CITY OF PORTLAND, MAINE
DEVELOPMENT REVIEW APPLICATION
PLANNING DEPARTMENT PROCESSING FORM
ADDENDUM

Label Ave 62-66 (lot 88)

RE: Conditions of Approval-Single Family
60 Label Avenue

CITY OF PORTLAND, MAINE
 SITE PLAN REVIEW (ADDENDUM)
 CONDITIONS OF APPROVAL

Pg 2

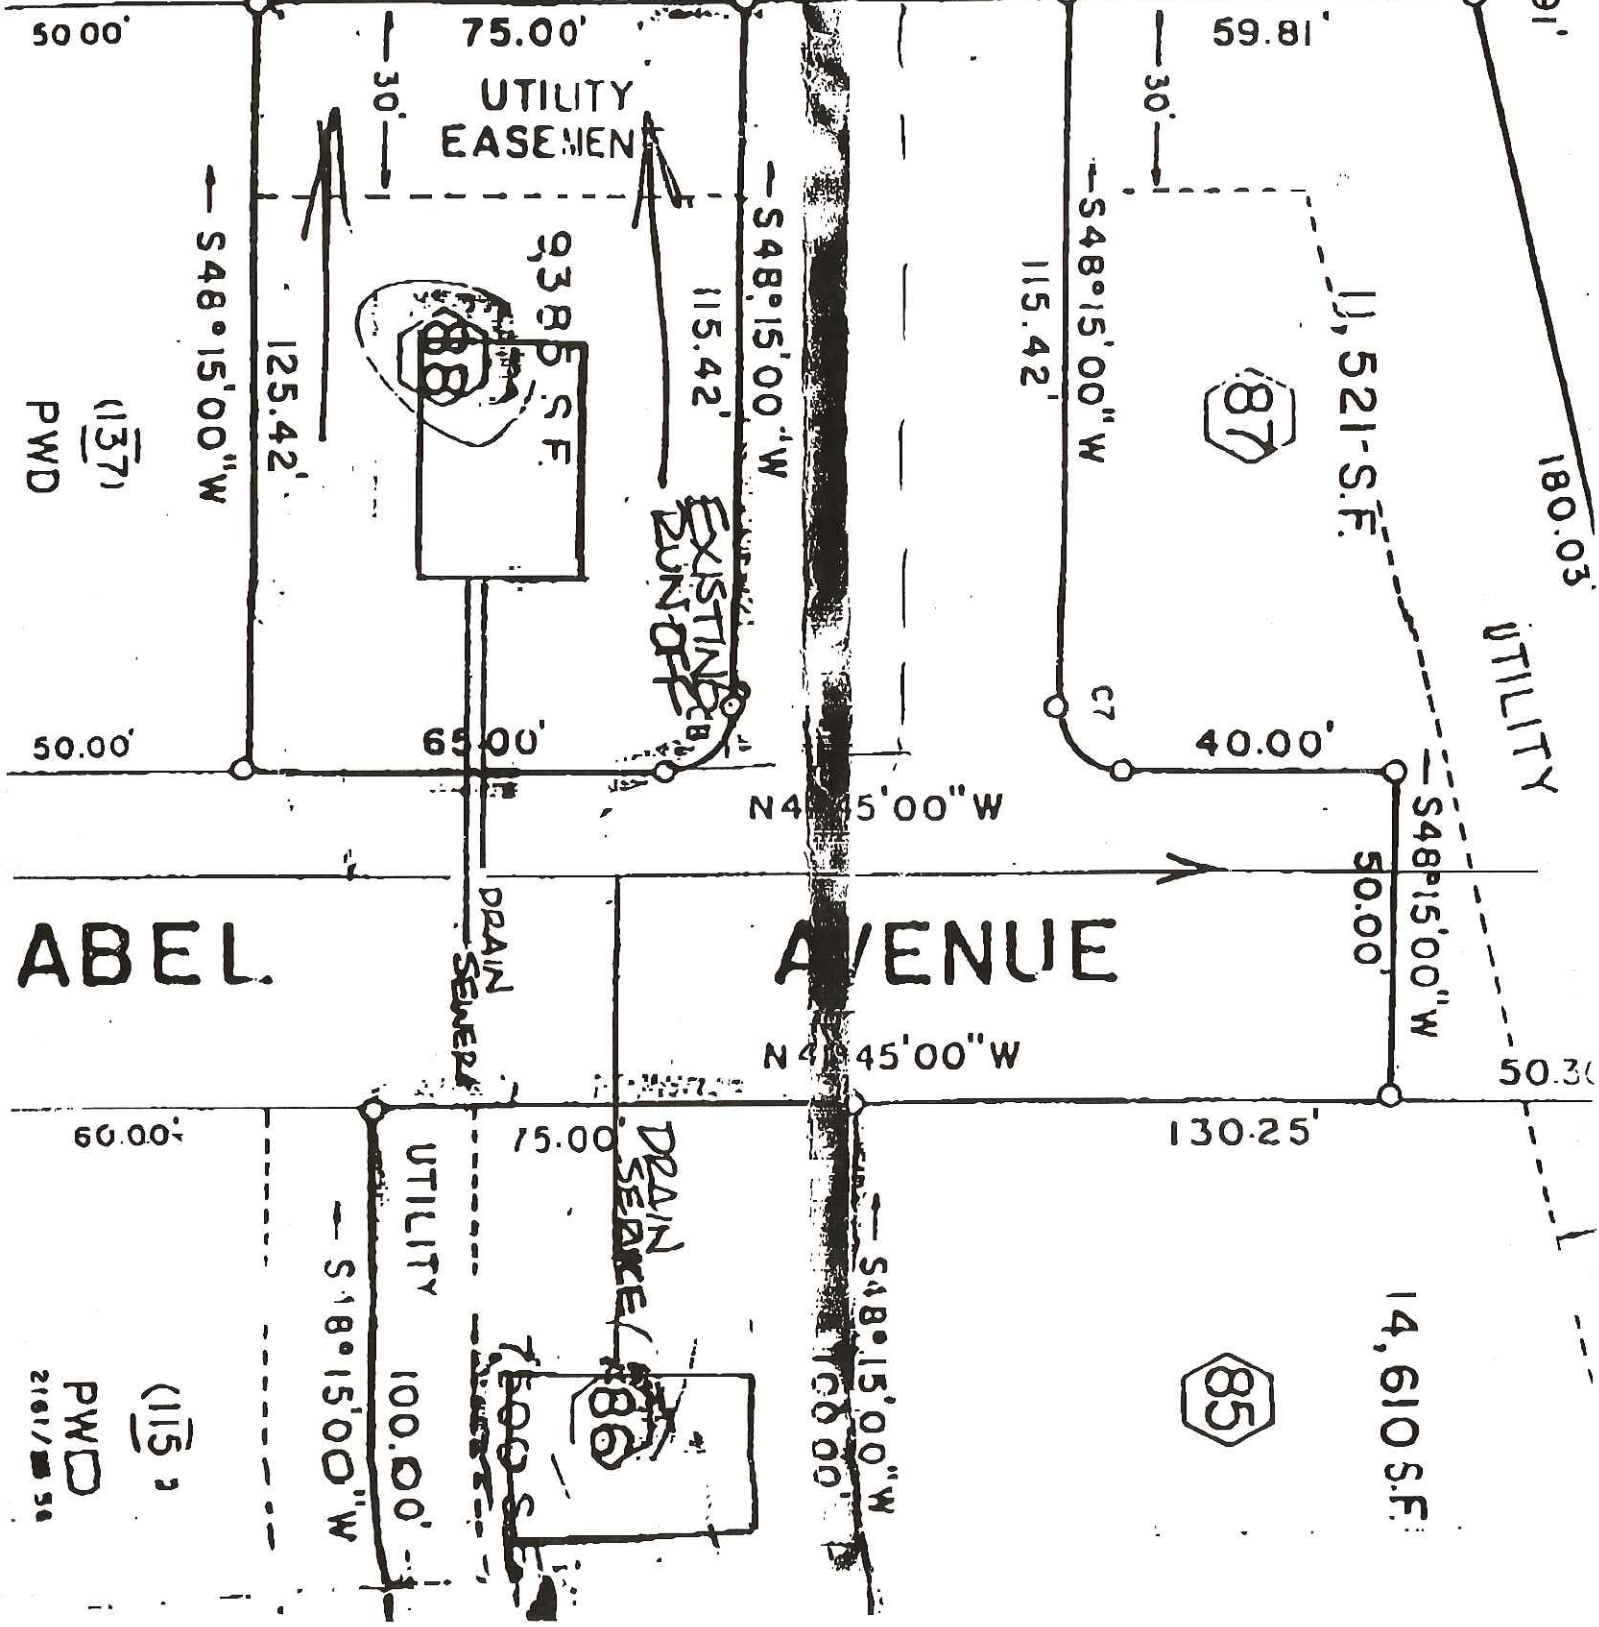
Pg 2 VIS FROM THE CURRENT SUBDIVISION.

Page 3

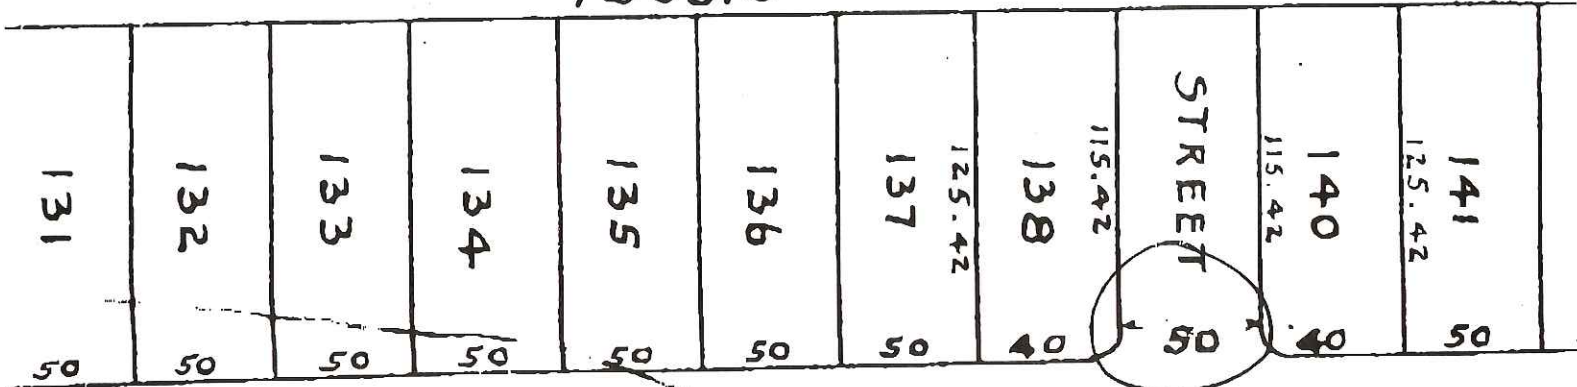
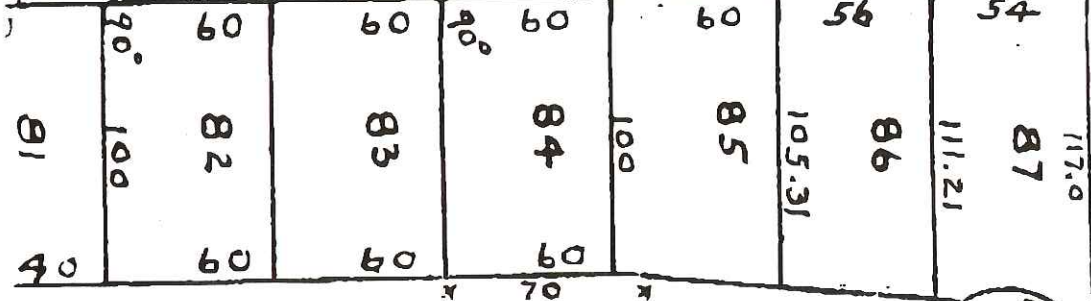
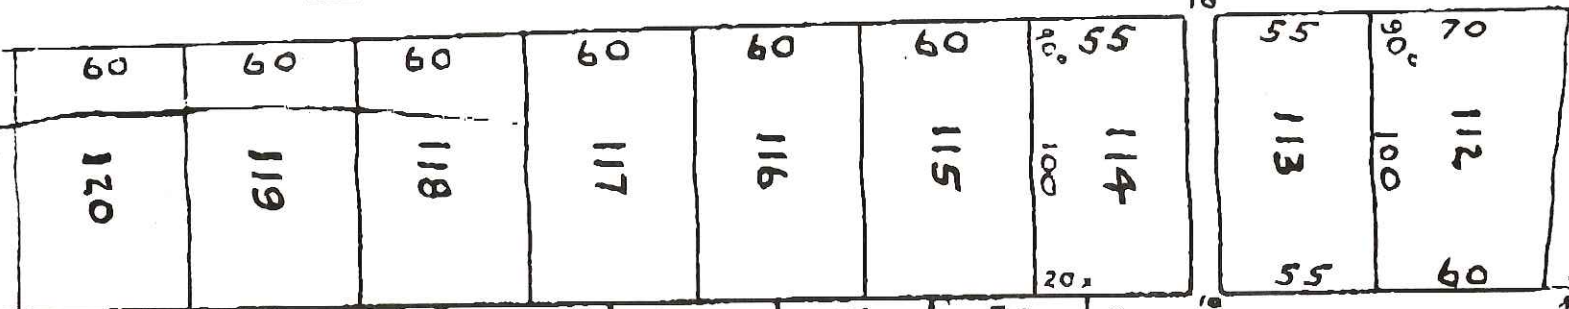
Pg 3 SEEMS TO HAVE BEEN THE ORIGINAL
SUBDIVISION.

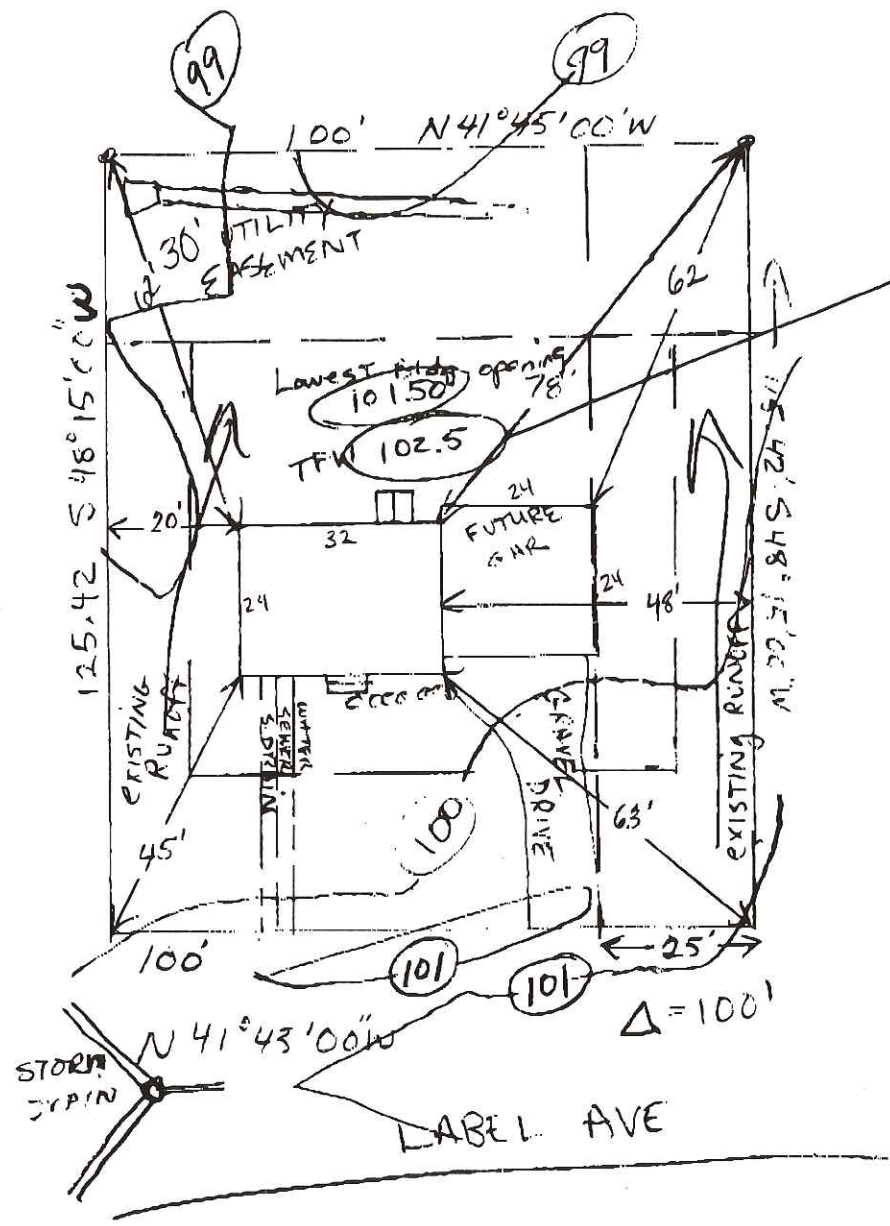
Per your comment, Tony, I visited the site with the file to review the use of the turnaround for access to the lot abutting the subject address. I discussed the turnaround with the homeowner at the time of my visit.

As you know, site plan approval for this address required that a turnaround easement be provided. The turnaround was required because an abutting right of way had been vacated and the right of way was merged into the abutting lots. The original location for the turnaround was within this enlarged lot. After discussing the events at the time of completion of the house with the homeowner, she reminded me that the location of the turnaround easement was relocated to include a portion of the other half of the vacated right of way acquired by the abutter. The new location was established after Custom Built Homes took the initiative to approach the abutter for permission to construct half the turnaround and easement within his property. Prior to this construction, this homeowner had access to the lot from the curb cut of the vacated right of way. I do not know if Custom Built Homes negotiated the easement with the understanding that his drive would stay where it was. The easement was executed and recorded. I do not know if access to the lot through the easement is referenced in the description of the recorded easement.

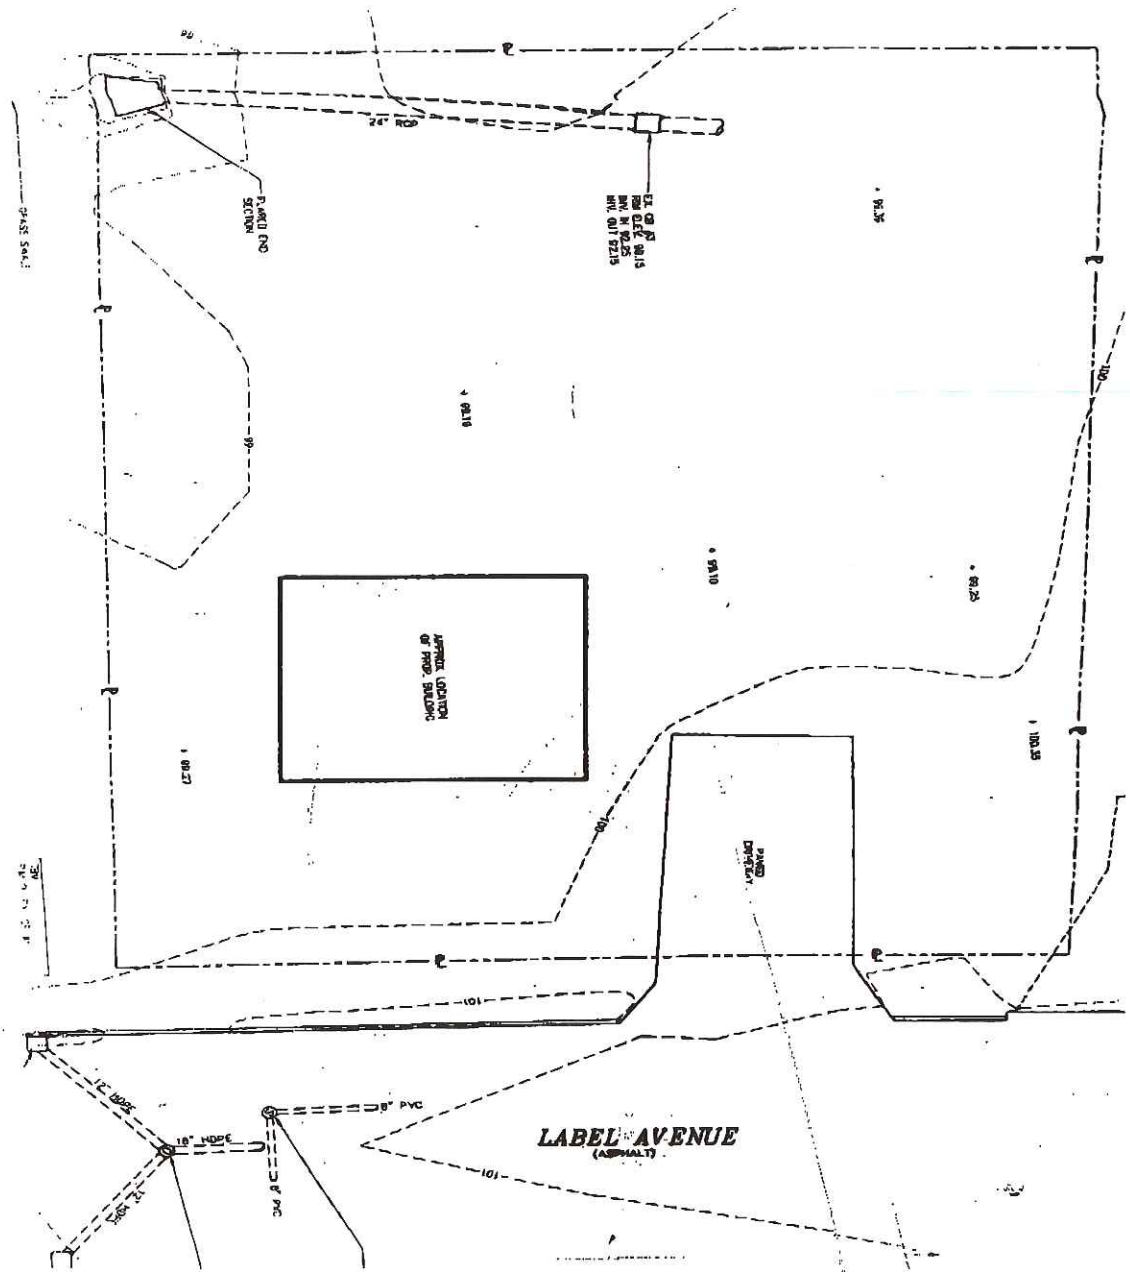
Jim,
My plan was prepared from the original subdivision plan, plus the city vacated the street and gave each abutter 25'.

Please let me know if this is sufficient.
